**Harker Heights  
Planning and Zoning  
Commission  
Meeting & Workshop**

## PLANNING AND ZONING COMMISSION MEMORANDUM

1. Motion to **approve, approve with conditions, or disapprove with explanation** a request for Preliminary Plat for the subdivision referred to as The Enclave at Indian Trail, on property described as a 16.92 acre tract of land situated in the W. E. Hall Survey, Abstract No. 1086, and the J. M. Roberts Survey, Abstract No. 3, and being all of the called 2.980 acre tract of land described in a deed to Terra Azul Developments, LLC., recorded in Instrument No. 201300048431, Deed Records of Bell County, Texas, all of the called 7.971 acre tract of land described in a deed to Terra Azul Developments, LLC., recorded in Instrument No. 201300048422, Deed Records of Bell County, Texas, all of the "Parcel 1" called 3.003 acre tract of land described in a deed to Terra Azul Developments, LLC., recorded in Instrument No. 201300048429, Deed Records of Bell County, Texas, all of the "Parcel 2" called 2.649 acre tract of land described in a deed to Terra Azul Developments, LLC., recorded in Instrument No. 201300048429, Deed Records of Bell County, Texas, and a part of Lot 1,

**THE ENCLAVE**  
**WATER LAYOUT**

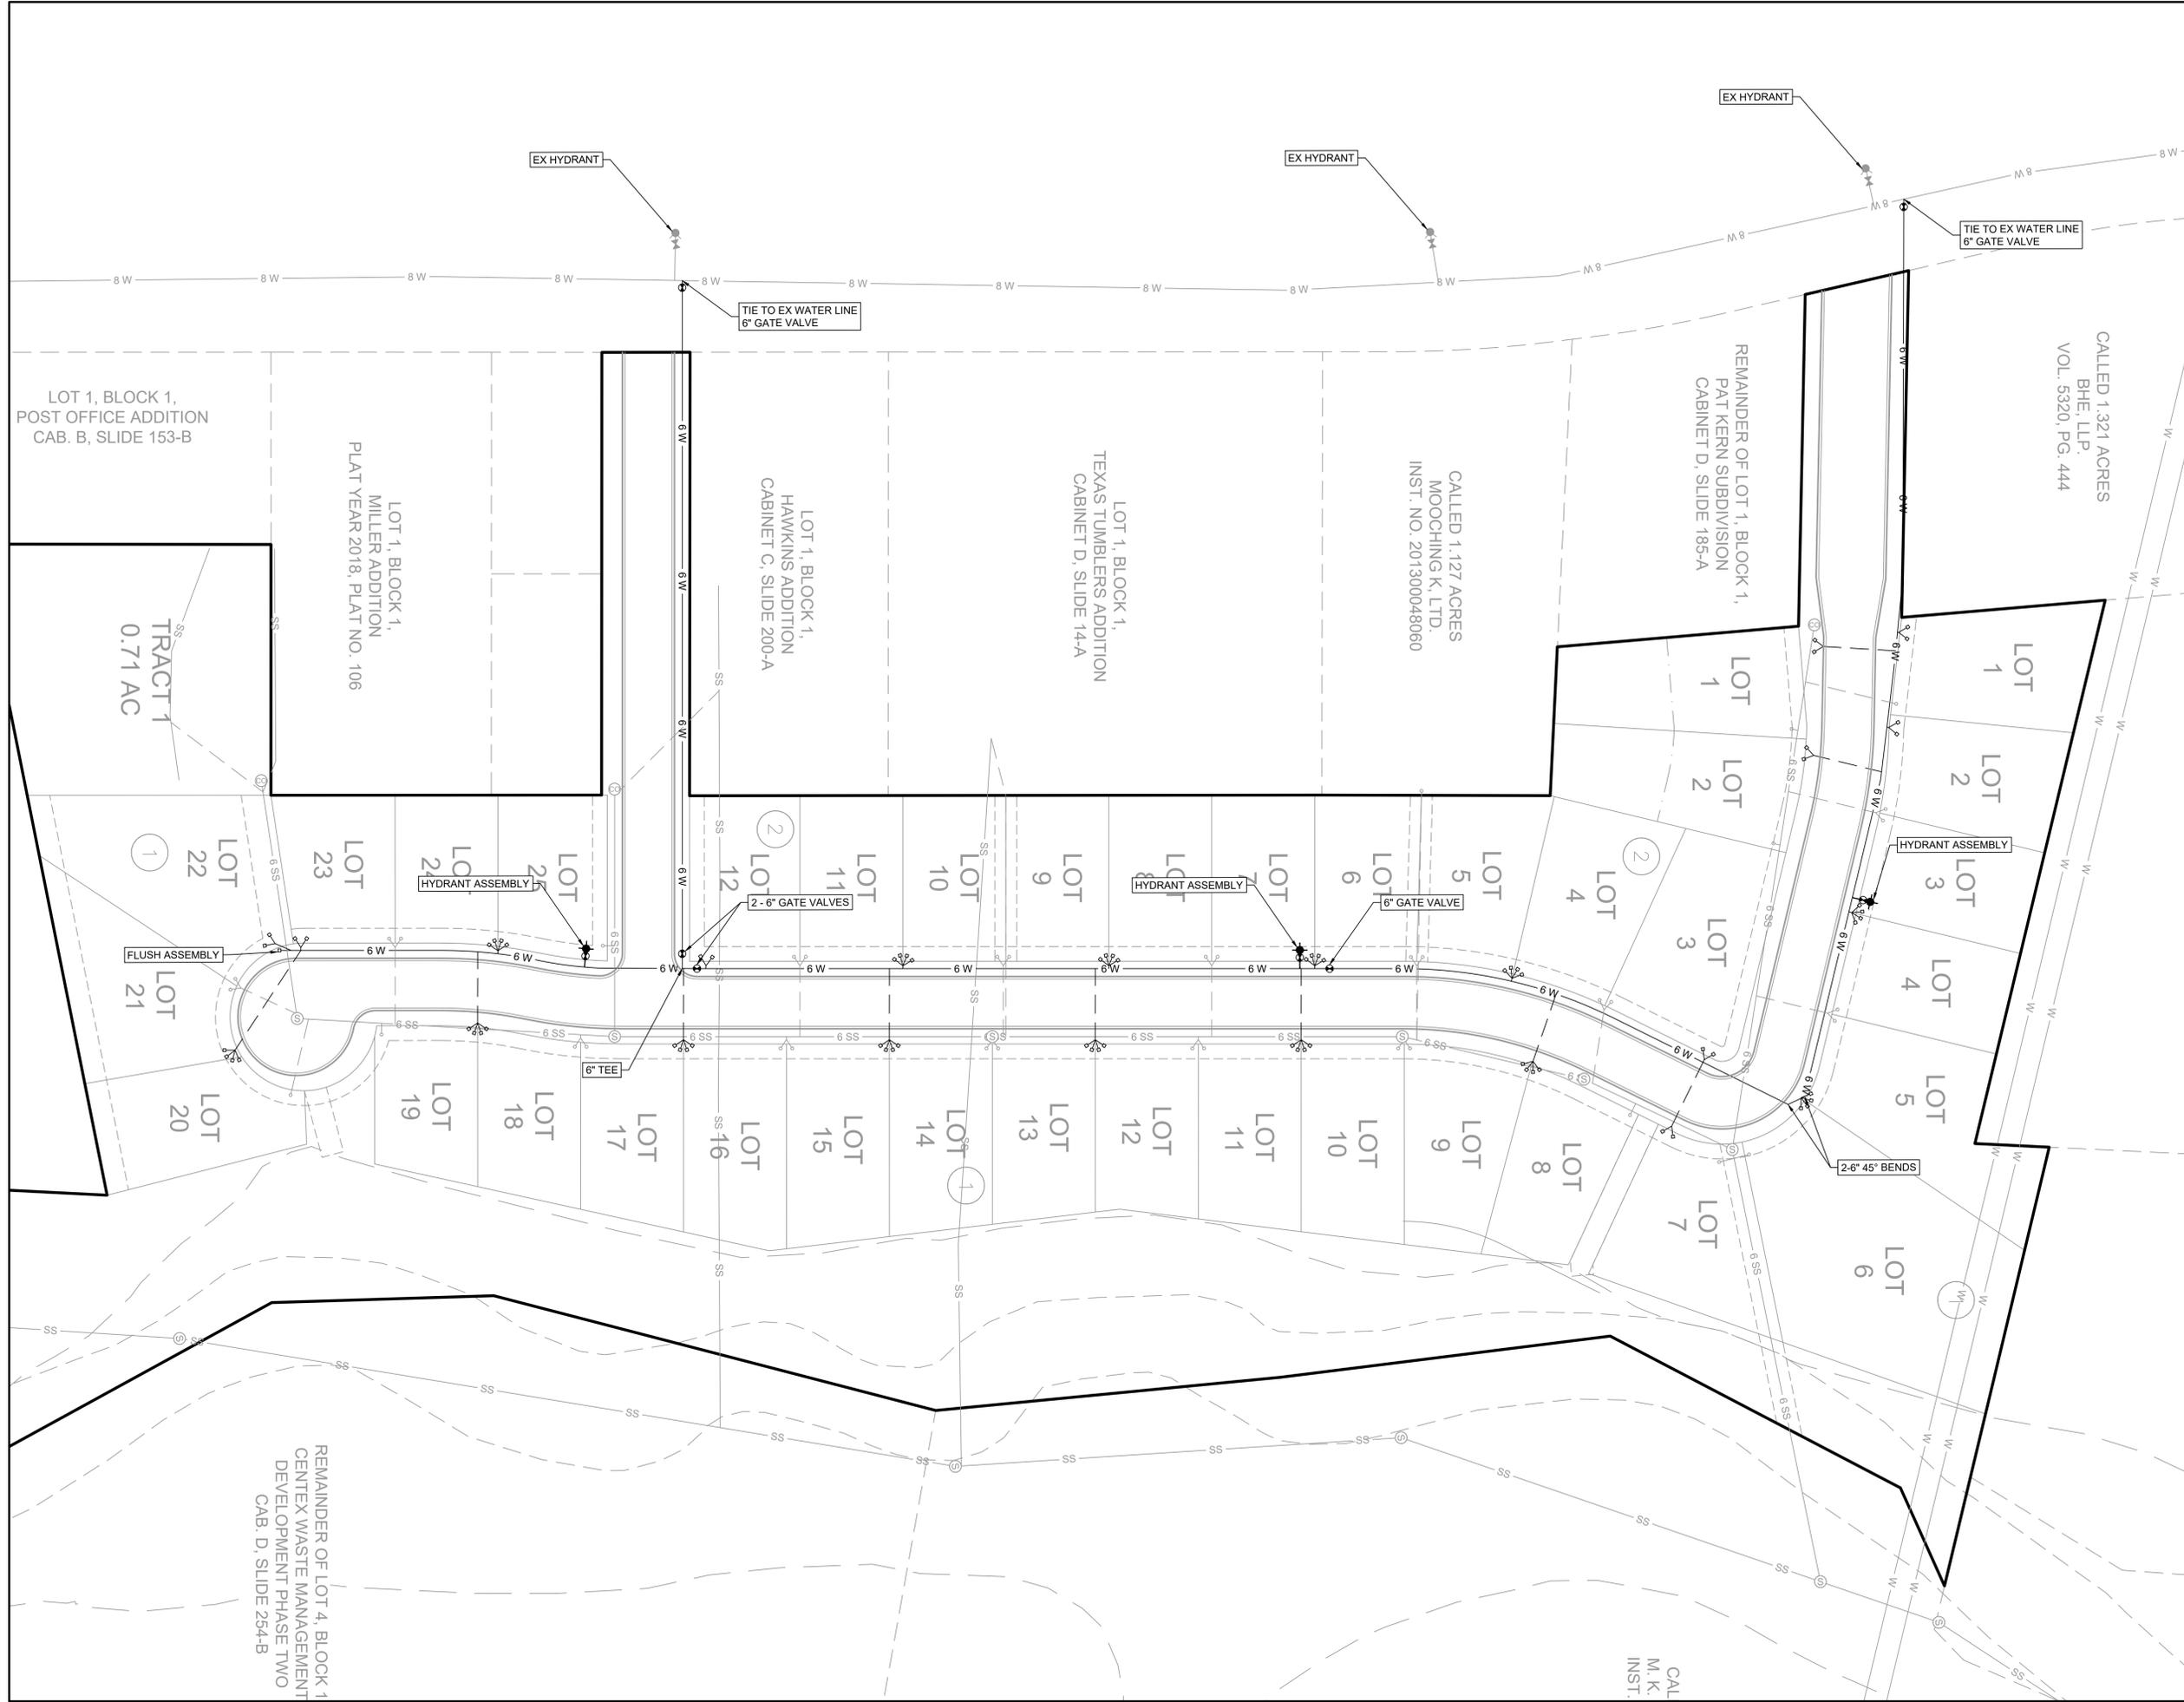
1. Add a 6-inch gate valve to the water line in the middle of Lot 6.
2. Provide an energy dissipation/rip rap detail for the underground storm sewer outfalls.
3. For the storm sewer pipes: Annotate the pipe diameters and pipe material type.
4. During the 10-year, 25-year and 100-year storm events, what will prevent the storm water runoff from Enclave Blvd. from jumping the curb and inundating the homes on Lot's 16 and 17? Section 158.03 of The City of Harker Heights Drainage Criteria Manual requires the following:

1. Add a 6-inch gate valve to the water line in the middle of Lot 6.  
**Gate valve has been added.**
2. Provide an energy dissipation/rip rap detail for the underground storm sewer outfalls.  
**Riprap has been added to sheet 3. Final design and details will be part of the construction plans and reports.**
3. For the storm sewer pipes: Annotate the pipe diameters and pipe material type.  
**Preliminary pipe sizes and material has been added to sheet 3. Final design and details will be part of the construction plans.**
4. During the 10-year, 25-year and 100-year storm events, what will prevent the storm water runoff from Enclave Blvd. from jumping the curb and inundating the homes on Lot's 16 and 17? Section 158.03 of The City of Harker Heights Drainage Criteria Manual requires the following:

**THE ENCLAVE**  
**SEWER LAYOUT**

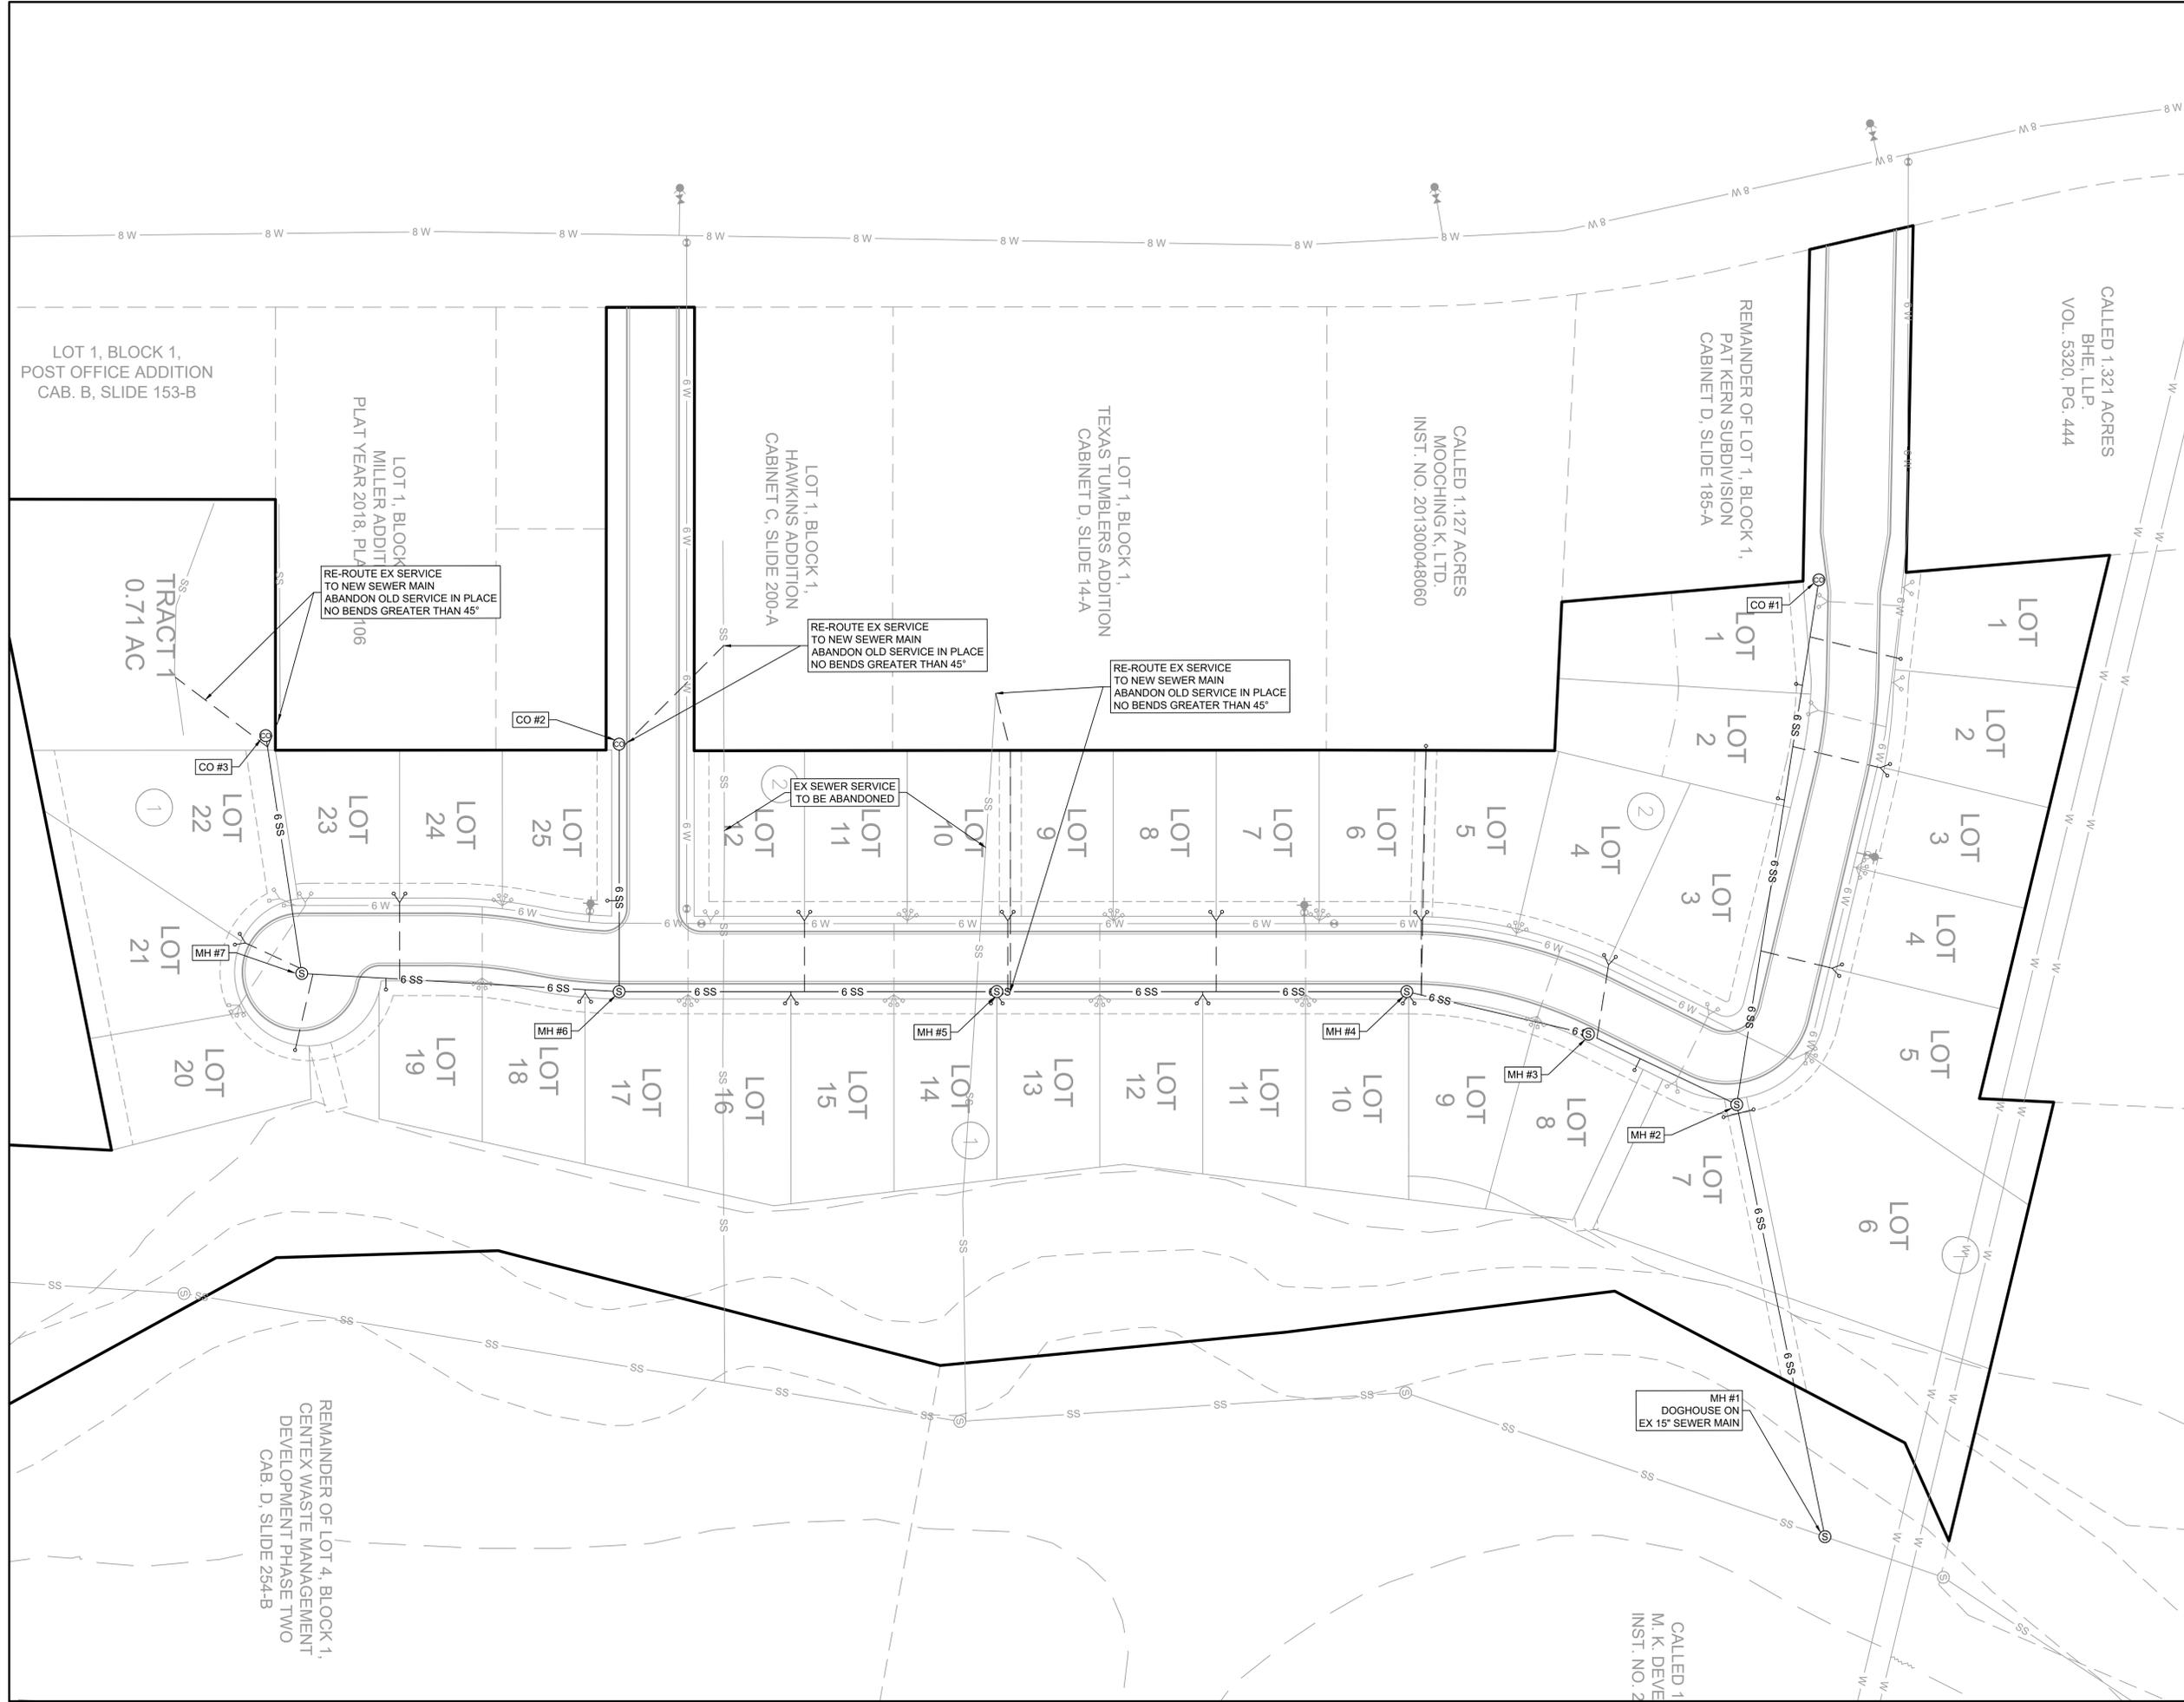
21. Engineering Sheet 5: Applicant shall extend the proposed sewer main through Lot 1 Block 1, and Lot 1, Block 2 to the western parcel boundary west.

17. Plat Dedication Page: Applicant shall provide utility easements for the existing sanitary sewer lines and services (Lot 12, Block 2; Tracts 1 & 2, Lots 19-22, Block 1) or annotate on the engineering sheets what the intent is for the offsite services.

22. Engineering Sheet 5 & Plat Dedication Page: applicant shall verify service location to the 1.127 acre tract behind Lots 5 & 6, Block 2, to Miller Addition behind Lots 32 & 24, Block 1, and Post Office Addition subdivision west of Tract 1 and provide for a utility easements accordingly.

**All existing service lines will be re-routed and tied into The Enclave's sewer system. See sheet 5 for proposed re-routing of each service and their corresponding easement locations.**

**Sewer has been extended to the western boundary.**
22. Engineering Sheet 5 & Plat Dedication Page: applicant shall verify service location to the 1.127 acre tract behind Lots 5 & 6, Block 2, to Miller Addition behind Lots 32 & 24, Block 1, and Post Office Addition subdivision west of Tract 1 and provide for a utility easements accordingly.

**A utility easement has been added to Lot 22 to account for sewer services re-routing. From our information, the post office tract's service goes around this property to the south. If this is found to not be the case during the creation of construction plans, the service will be re-routed to the sewer main as with the other services in Tract 1. All services through Tract 1 will have easements re-defined with the final plat once the re-routing is designed with construction plans. The 1.127 acre tract is currently un-developed. An easement has been added between lots 5-6, block 2 and a service will be extended to the property line.**
